## **A503 Seven Sisters Road & Tollington Road Cycleway 50 Phase 1**

Stage 2 Road Safety Audit

Ref: 3997/003/A503/TLRN/2022

**Location:** C – Warlters Road Toucan Crossing

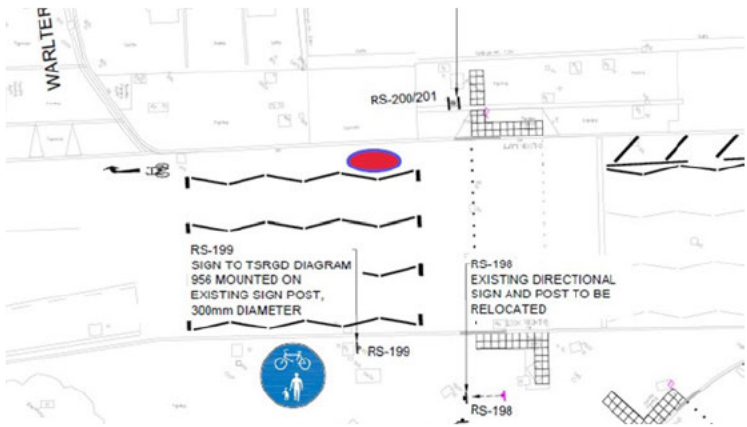
**Summary:** Risk of collisions between pedestrians and cyclists on the north side of Camden Road.

The layout of the Toucan crossing by Warlters Road is unusual in that cyclists appear to be intended to cross from the southern dropped kerb but then remain on the carriageway on the north side of Camden Road, despite the northern footway being designated as shared use immediately around the crossing point. While map-type signing is proposed for cyclists from the south, it is not immediately apparent from these that cyclists are required to remain on the carriageway and this may result in cyclists continuing onto the northern footway and then joining Warlters Road from the raised table at the junction, risking conflict with pedestrians.

Measures to clarify the intended route for cyclists should be provided. This may include, but is not limited to, additional road markings immediately adjacent to the Toucan crossing to inform cyclists that they are required to remain on the carriageway once they have crossed Camden Road.

Design Organisation Response	Accepted / Part Accepted / Rejected
<p>This has been addressed within the previous RSA1 problem D section 3.1.4 and was signed off with the intention of retaining the proposed layout without any variation.</p> <p>An additional cycle logo 1057 could be placed at the entry to the kerb side cycle lane to increase awareness in line with section 15.8.17 of TSM Chapter 6.</p>

Agree with the Designer's response. It is understood, however, that a sign in the location suggested would not comply with the requirement that zig-zag markings may not have any other road markings in parallel, therefore, should not be installed.
